**PLANNED UNIT DEVELOPMENT****STAFF REPORT****Date: September 7, 2006**

<b><u>DEVELOPMENT NAME</u></b>	The Preserve Subdivision
<b><u>DEVELOPMENT NAME</u></b>	The Preserve Subdivision
<b><u>LOCATION</u></b>	North side of Girby road, 550'+ West of the North terminus of Pepper ridge Drive
<b><u>CITY COUNCIL DISTRICT</u></b>	District 6
<b><u>PRESENT ZONING</u></b>	B-3, Community Business
<b><u>AREA OF PROPERTY</u></b>	49.1± acres
<b><u>CONTEMPLATED USE</u></b>	Planned Unit Development Approval to amend a previously approved Planned Unit Development to allow the construction of a pigeonnier and parking within the common area on rue Preserve.
<b><u>TIME SCHEDULE FOR DEVELOPMENT</u></b>	Immediate
<b><u>ENGINEERING COMMENTS</u></b>	Must comply with all stormwater and flood control ordinances. Any work performed in the right of way will require a right of way permit. The applicant is responsible for verifying if the site contains wetlands. The site can be checked against the National Wetlands Inventory on the COM web site Environmental Viewer. If the site is included on the NWI, it is the applicant's responsibility to confirm or deny the existence of regulatory wetlands.

The applicant is

## BUILDING ELEVATION DETAIL

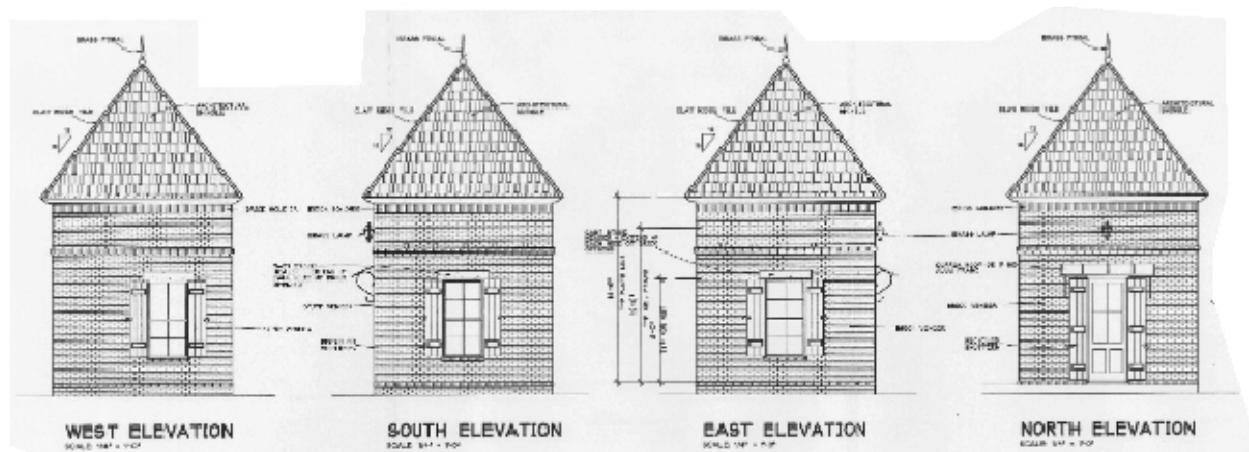
The applicant proposes the addition of a 14-foot x 14-foot structure and three parking spaces within the common area; this structure is commonly called a pigeonnier in some areas of South Louisiana. The developer would also add brick walls with varying heights and a water fountain with landscape features. This area will serve the subdivision as a small rest stop for the neighborhood with park benches and shaded trestle areas to enhance the beauty of this unique setting. The developer states the architectural features of the pigeonnier sets the entry tone of this unique development, the French Country Architectural design of the homes of The Preserve.

# DETAIL SITE PLAN

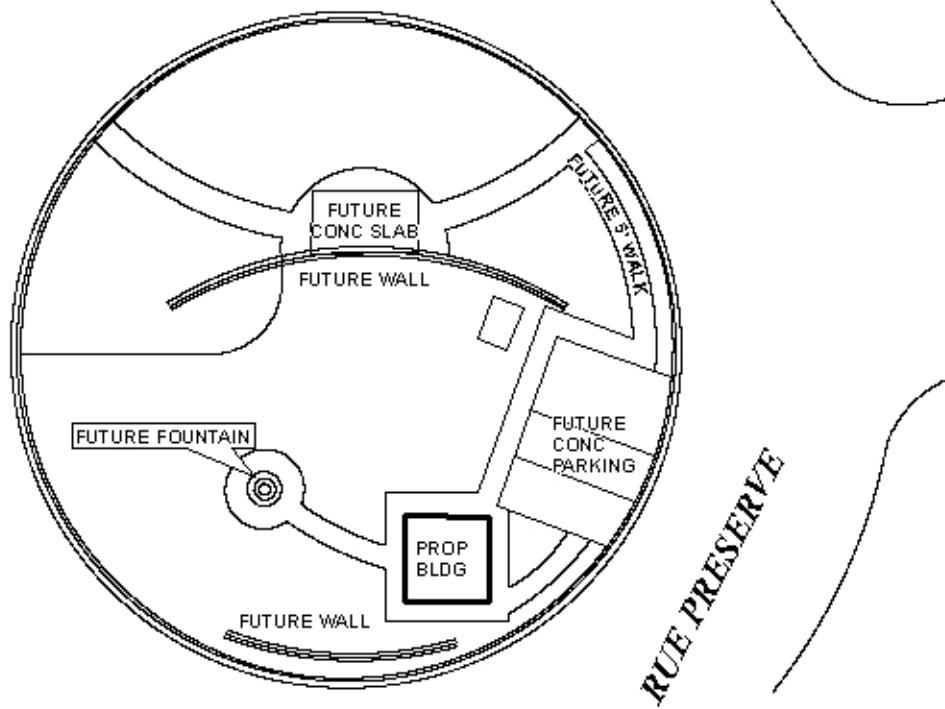
The structure, parking spaces, water features, benches and brick walls would seem to enhance the beauty and unique setting of the neighborhood the placement and size should be approved by Traffic Engineering so as not to compromise access and circulation within the existing traffic circle.

Based upon the preceding, this application is recommended for approval subject to the following conditions: 1) that placement, size and location of the structures and parking spaces to be approved by Traffic Engineering; 2) property to be developed in compliance with state and local laws that pertain to tree preservation and protection on both city and private properties (State Act 61-929 and City Code Chapters 57 and 64); and 3) full compliance with all municipal codes and ordinances.
